PRATT & WHITNEY CANADA
SERVICE BULLETIN

P&WC S.B. No. 41121

TURBOSHAFT ENGINE
HOUSINGS FOR ACCESSORY GEARBOX AND INLET CASE - IDENTIFICATION OF

PT6C-67C, PT6C-67C1

AGB Housing Marking Location
Figure 1

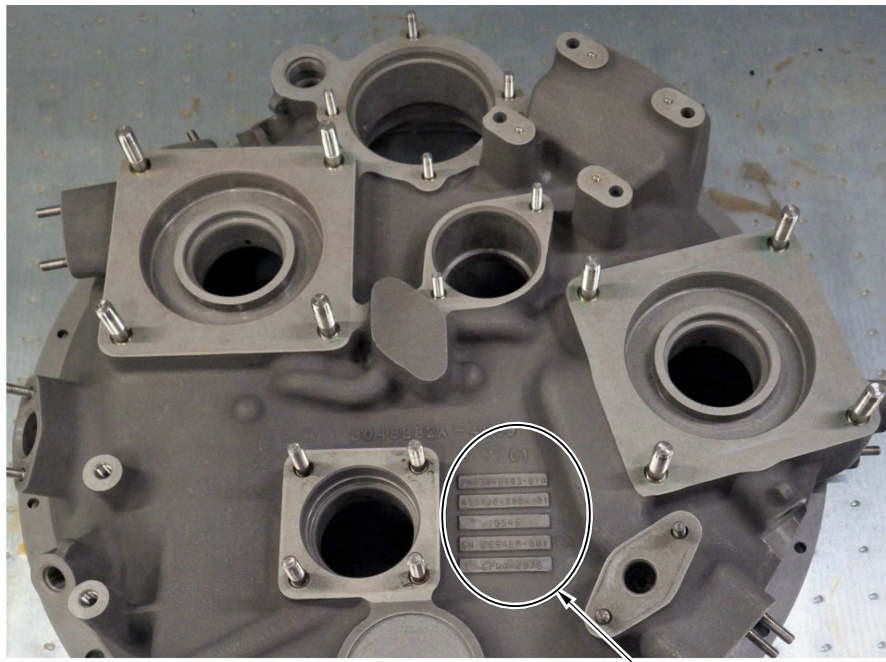
- (1) Vibropeen AGB housing in Area A with prefix "MX" followed by the engine serial number (Ref. Fig. 1).

AGB Diaphragm Marking Location
Figure 2

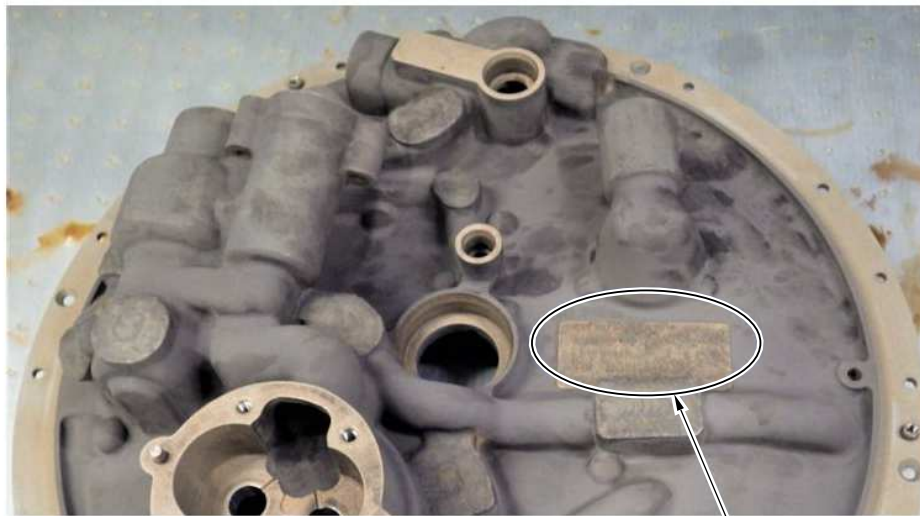
- (2) Vibropeen AGB diaphragm in Area B with prefix "MX" followed by the engine serial number (Ref. Fig. 2).

Inlet Case Marking Location
Figure 3

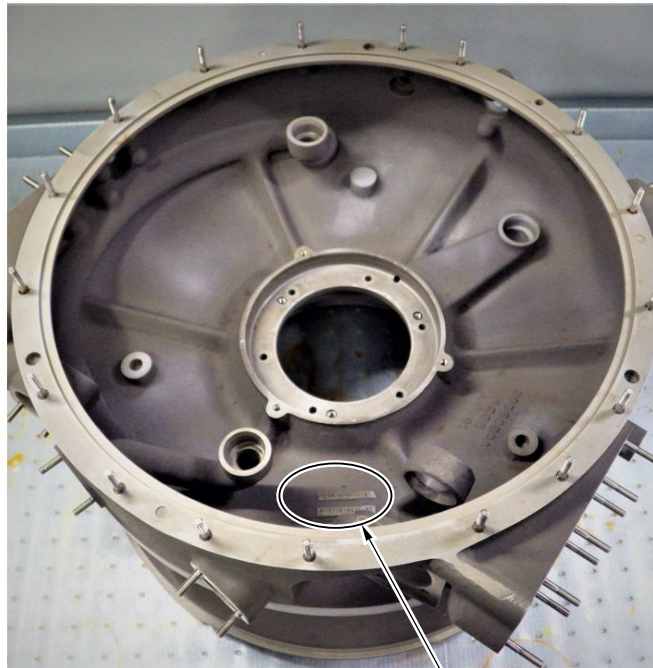
- (3) Vibropeen inlet case in Area C with prefix "MX" followed by the engine serial number (Ref. Fig. 3).
